Crossing Car Campus

CITY OF LAS VEGAS		DATE:
INTER-OFFICE MEMORANDUM		October 27, 2016
TO: Land Development Services Department of Building & Safety		FROM: Albert Sung, P.E. Flood Control Project Engineer Department of Public Works
SUBJECT:	Drainage Study for:	
	Crossing Care Campus	
Cross Streets:	NWC Center Crossing Rd & Desert Crossing Ct	COPIES TO:
File Number:	F:\Depot\DSMemos\DS4821B.doc	DRC Surveying Nevada, Inc.
Parcel Number:	138-19-419-006	Crossing Business Center 8, LLC
Zoning Action:	CRG-65728	Bart Anderson, P.E., DevCo
FEMA Flood Zone	YES	NO X
Proposed Storm Drain	YES	NO X

The Drainage Study for the subject project has been reviewed and:

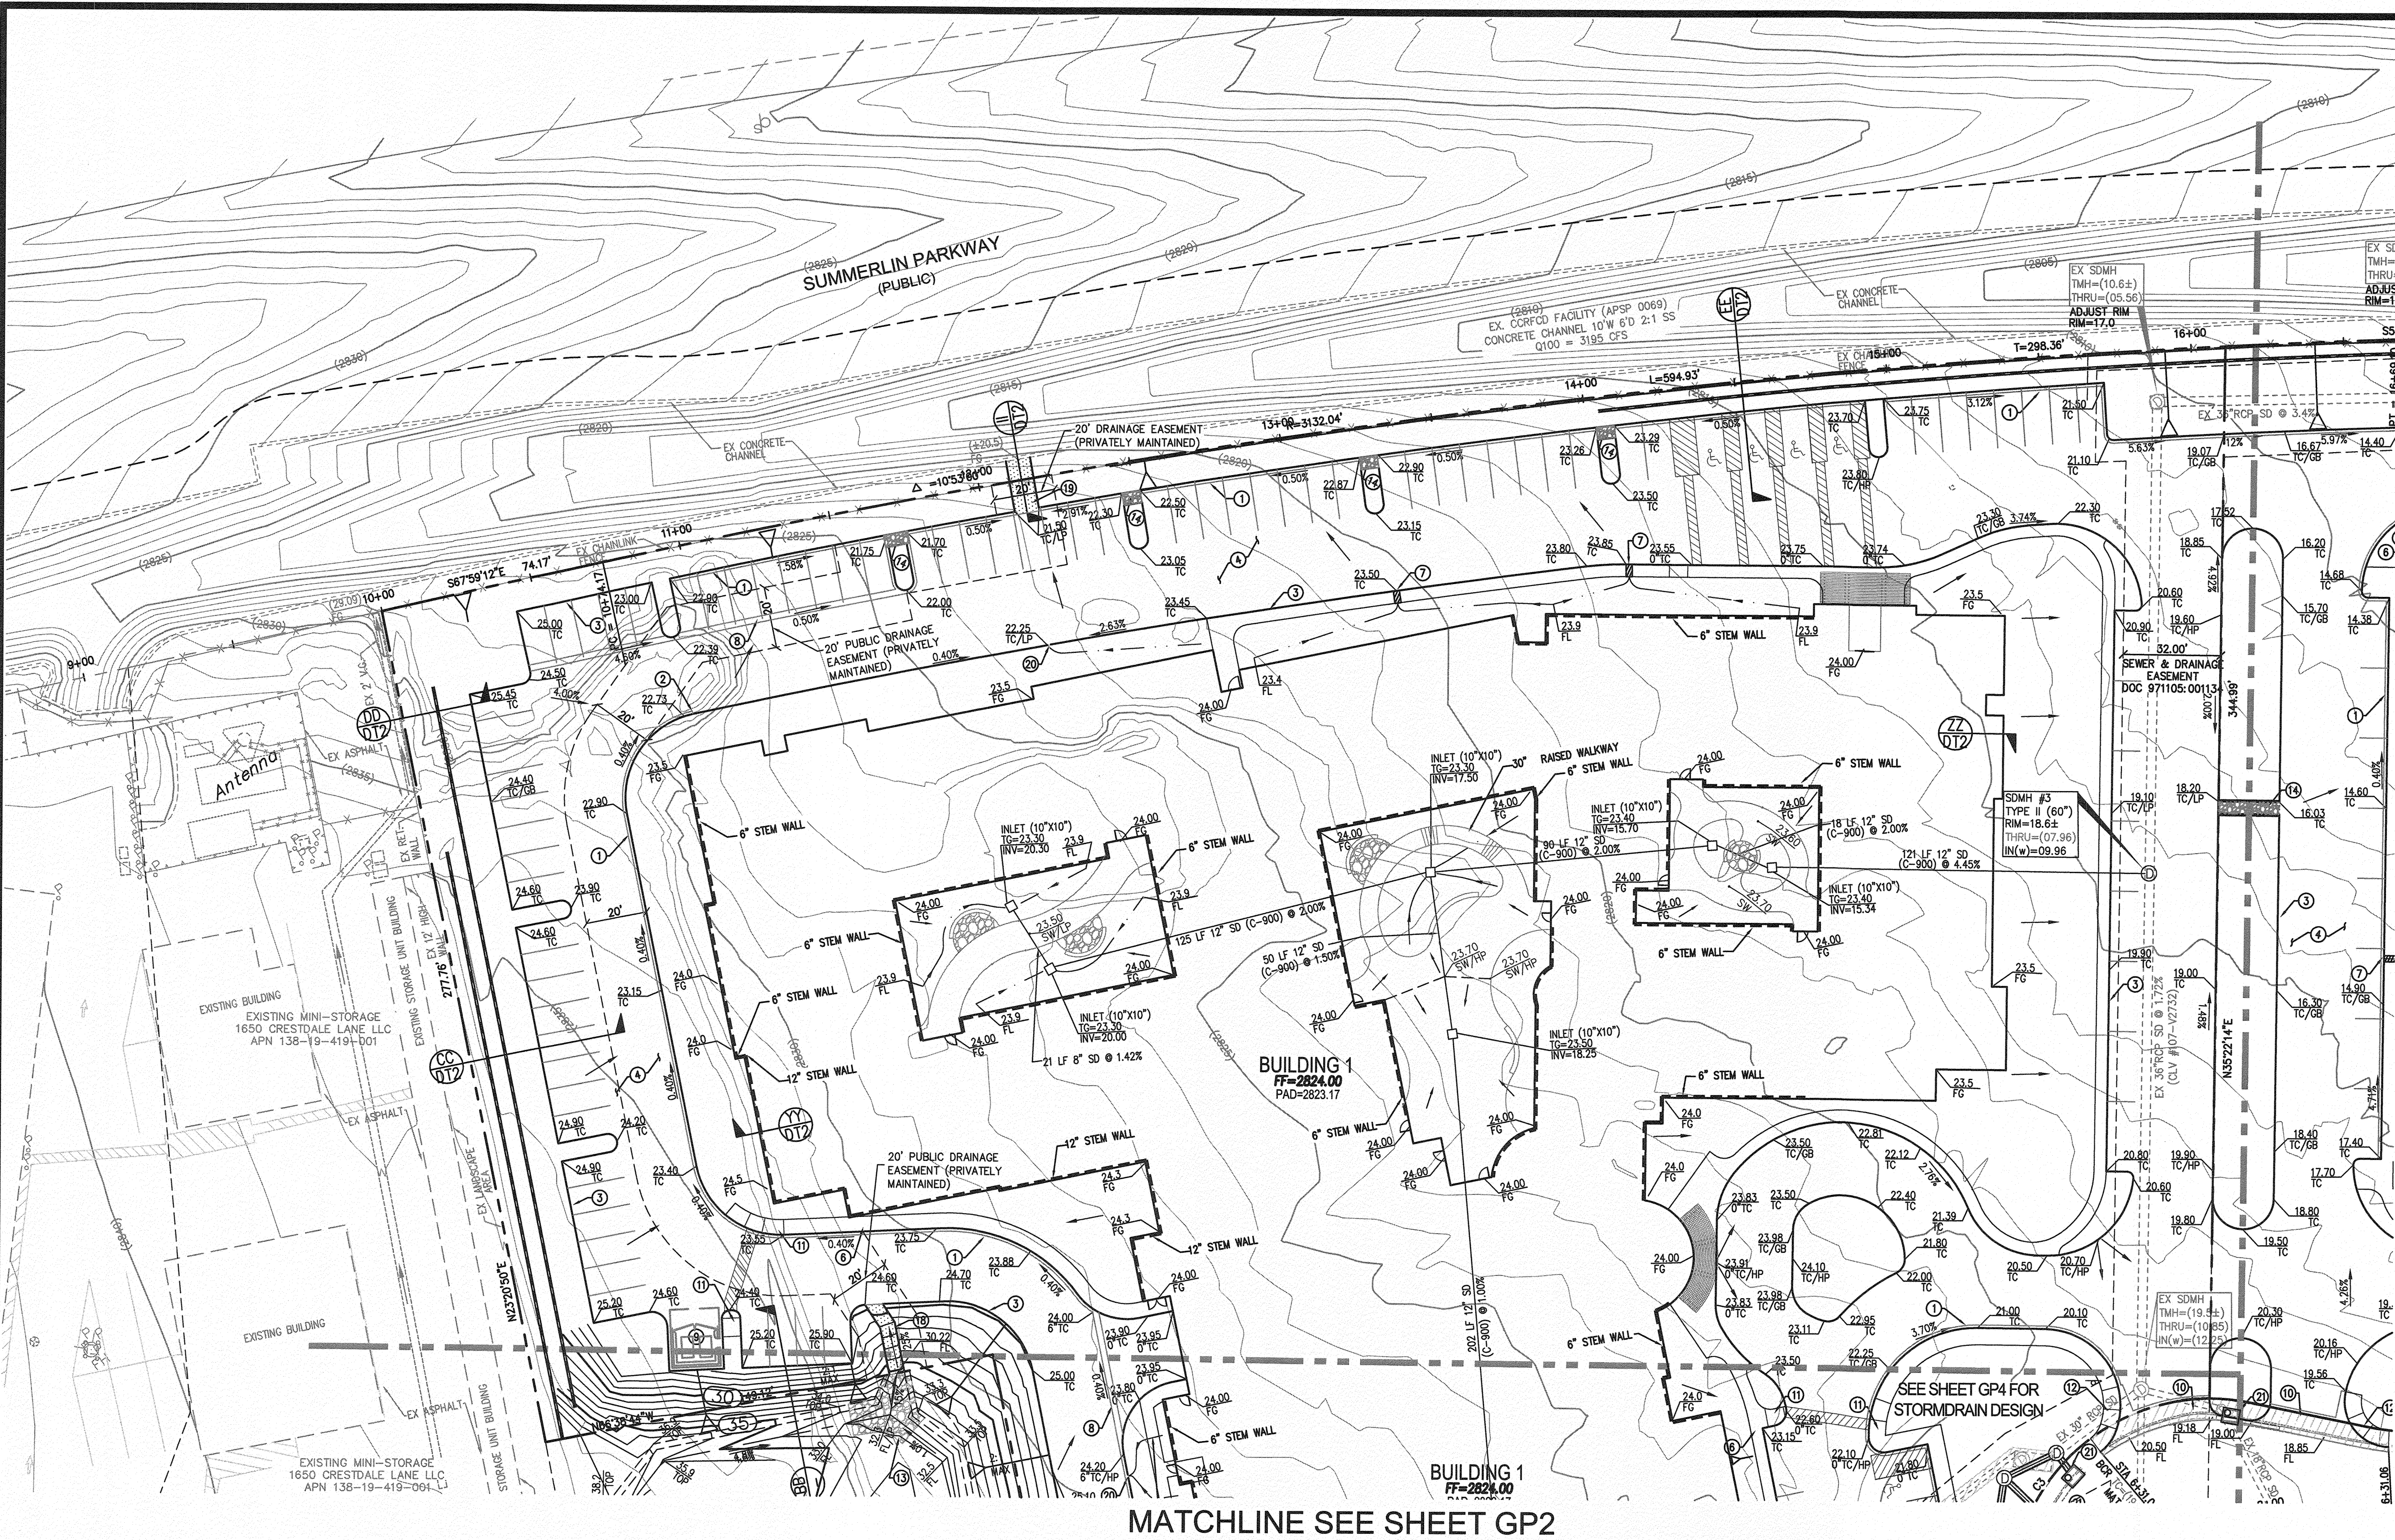
- 11. Label an existing storm drain in the main entrance of the development with City of Las Vegas recorded drawing number on the pertinent grading plan.**

11. Label an existing storm drain in the main entrance of the development with *City of Las Vegas* recorded drawing number on the pertinent grading plan.

Grading Plan Sheet GP4 was revised to label the existing storm drain with the CLV recorded drawing number at the main entrance.
